2015 PLOTTING SPRING ROAD  
 THE RESERVE AT MARIETTA

**Z-77  
 (2015)**

# Z-77

**ZONING COMMENTS:**

**ZP-01**

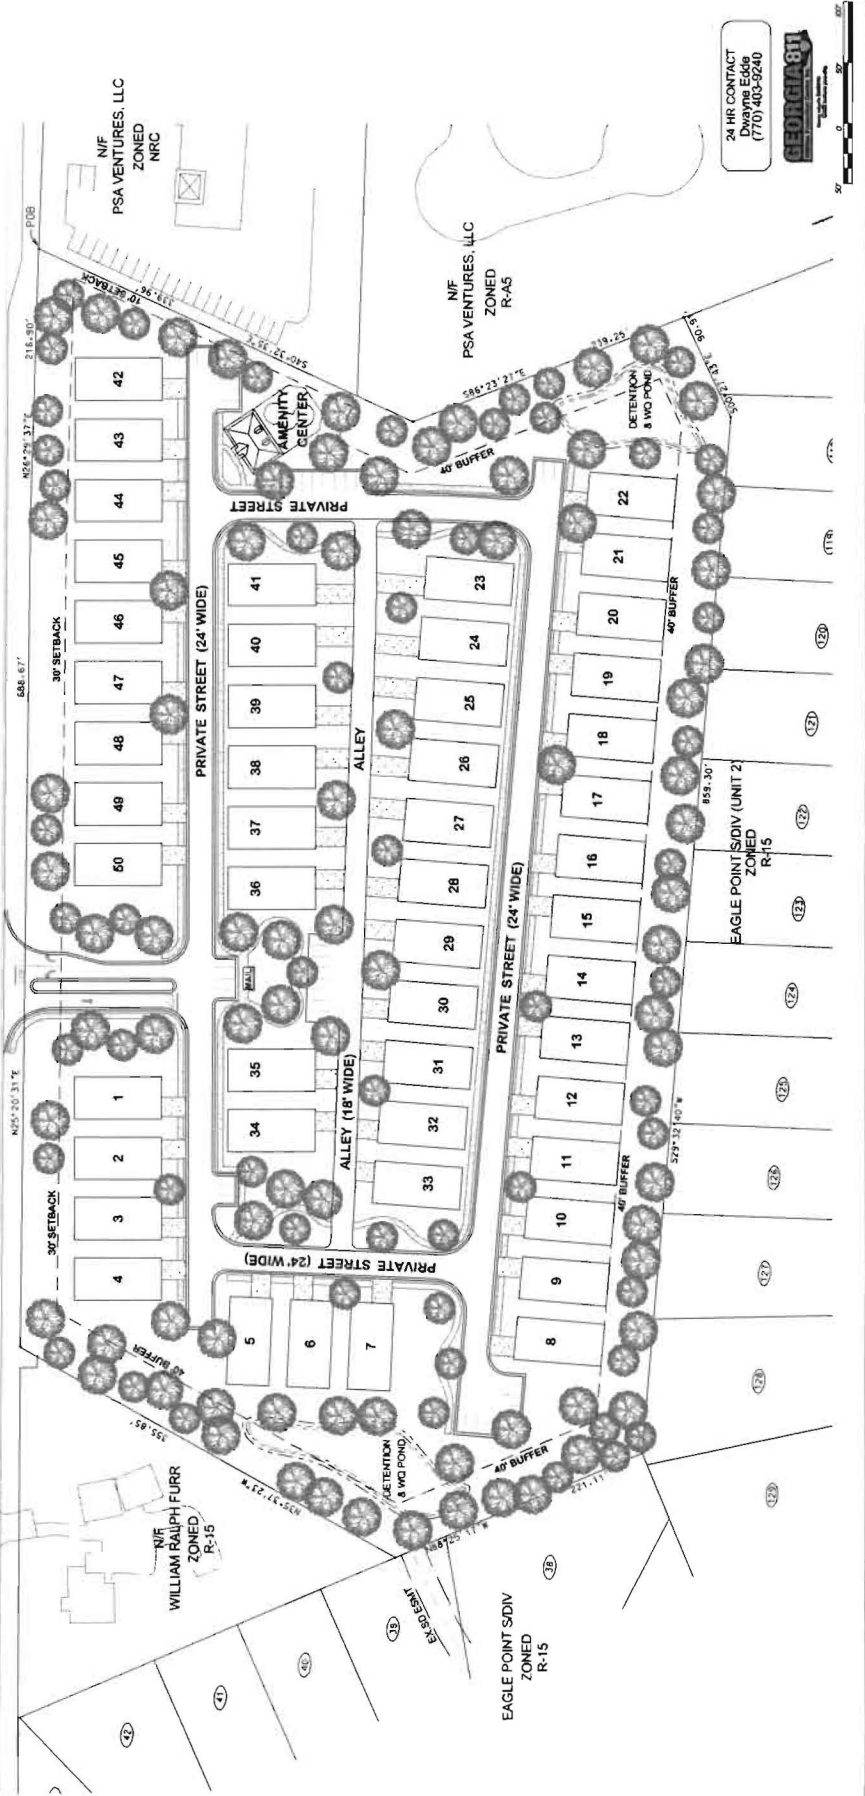
- No Stormwater controls shown \_\_\_\_\_
- Copy of survey is not current – Additional comments may be forthcoming when current site conditions are exposed.
- No site improvements showing on exhibit.

1. The majority of this site drains to the south into and through the Eagle Point Subdivision. To limit offsite bypass of runoff a drainage easement will be required along the rear of lots 8-22.
2. The southern detention facility must be tied directly to the existing downstream system within Eagle Point S/D and subject to the capacity of that system.

- Site plan received June 4, 2015, with the District Commissioner approving minor modifications;
- Water and Sewer Division comments and recommendations;
- Stormwater Management Division comments and recommendations; and
- Department of Transportation comments and recommendations.
